DFT PR-2024-010446

SI-2024-00774

RESPONSE TO: Code Enforcement Comments

2/24/2025 - COMMENT RESPONSES
To DFT 3rd Submittal – 5 March. 2025

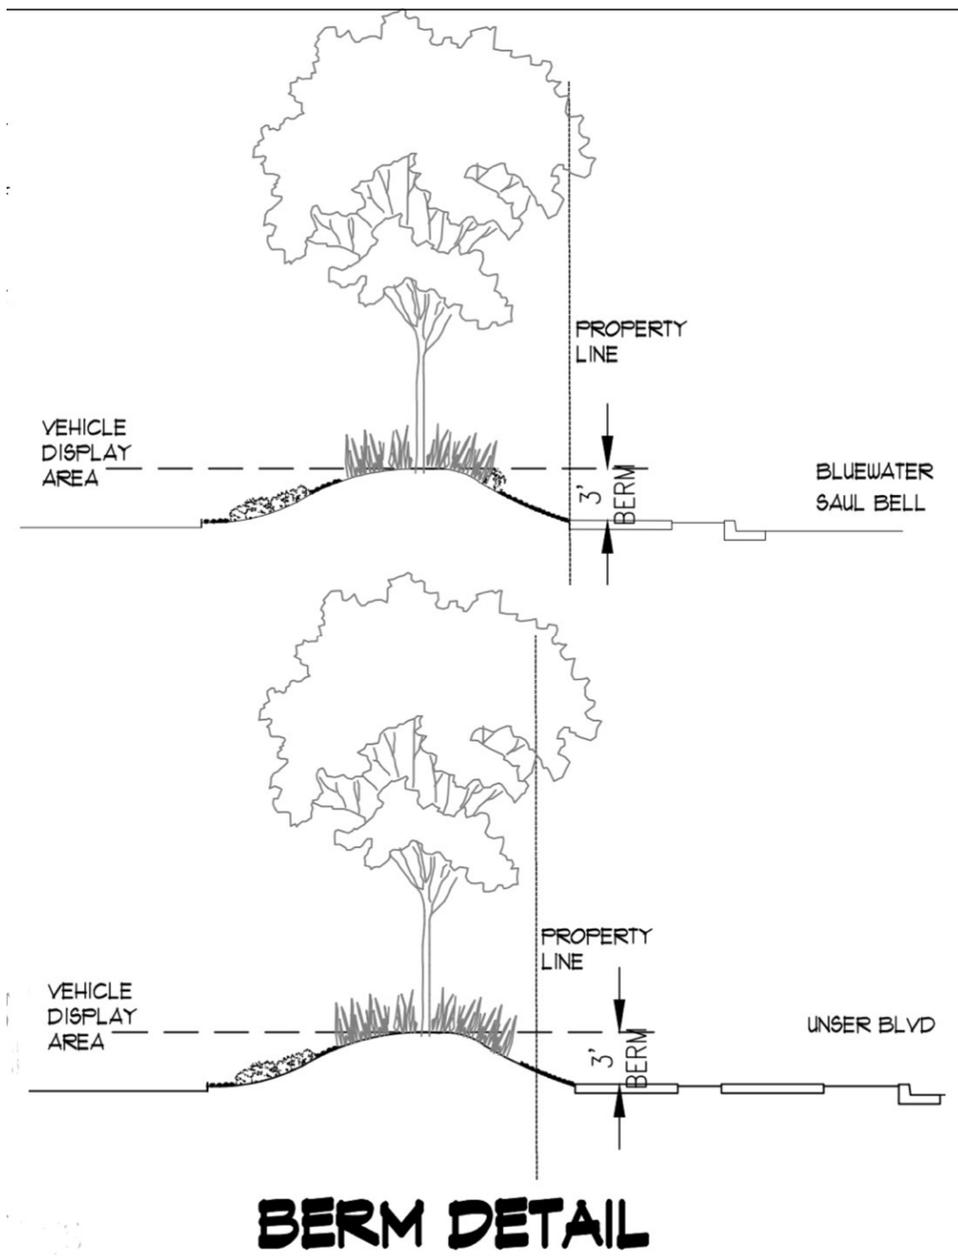
3. Bicycle spaces - IDO TABLE 5-5-5, pg 287: For, Non-residential uses not listed in this table; 3 spaces or 10% of required off-street parking spaces, whichever is greater. The bicycle spaces will be provided for using an anchored rack located within 50 feet of the primary entrance of the office building as shown on the **site plan (marked "B")** as per DPM and IDO 5-5.E.3 and E.4

REQUIRED	PROVIDED
Parking spaces-		
Off-street Parking	31	58
Bicycle requirements	3.1	5
Motorcycle requirements (26-50)	2	3
